STATE OF OHIO DEPARTMENT OF TRANSPORTATION

WAR-S RIVER & S MAIN NS

INSTALL NEW TRAFFIC SIGNALS AT W 6TH ST/S RIVER ST AND W 6TH ST/S MAIN ST INTERSECTIONS FOR RAILROAD PREEMPTION AND INTERCONNECTION WITH NORFOLK SOUTHERN GRADE CROSSINGS DOT #524892A AND 524894N. INSTALL CURB RAMPS AROUND THE W 6TH ST/S RIVER ST INTERSECTION AND ON THE SOUTH SIDE OF THE W 6TH ST/S MAIN ST INTERSECTION. INSTALLATION WILL INCLUDE ADA AND MUTCD COMPLIANCE. THE PROJECT LENGTH IS 0.10 MILES.

PROJECT ID
115153

TRAFFIC SIGNAL PLAN
SOUTH MAIN STREET & WEST 6TH STREET

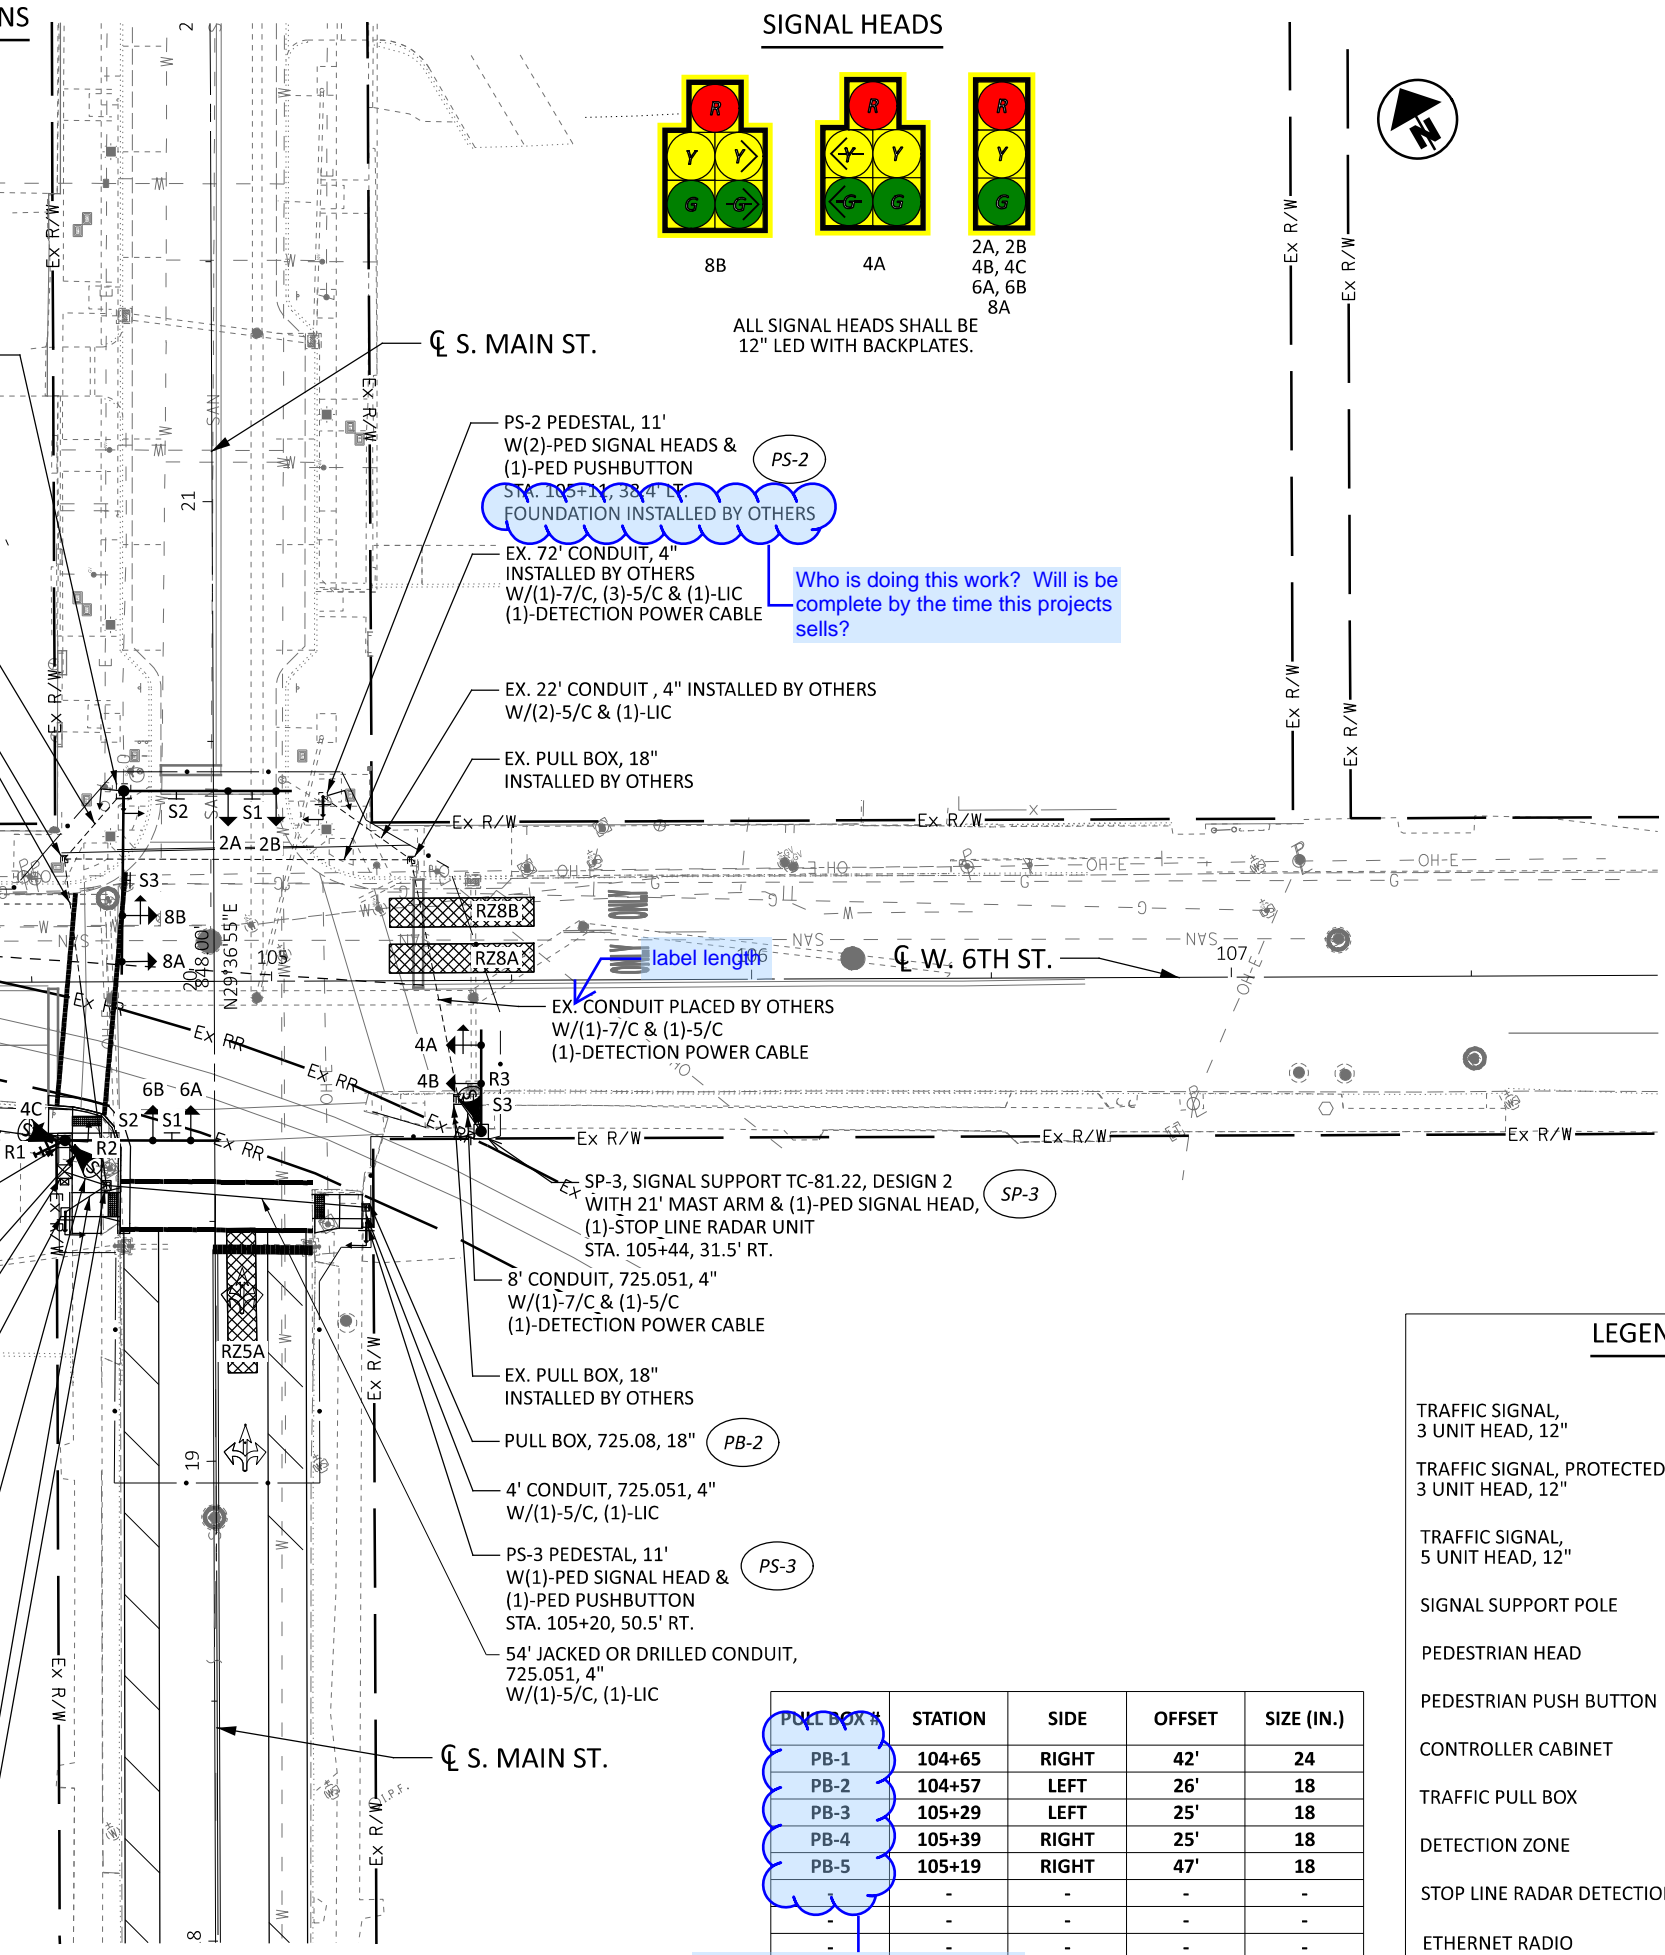
Label whether these are existing or proposed. Labels should match plan view
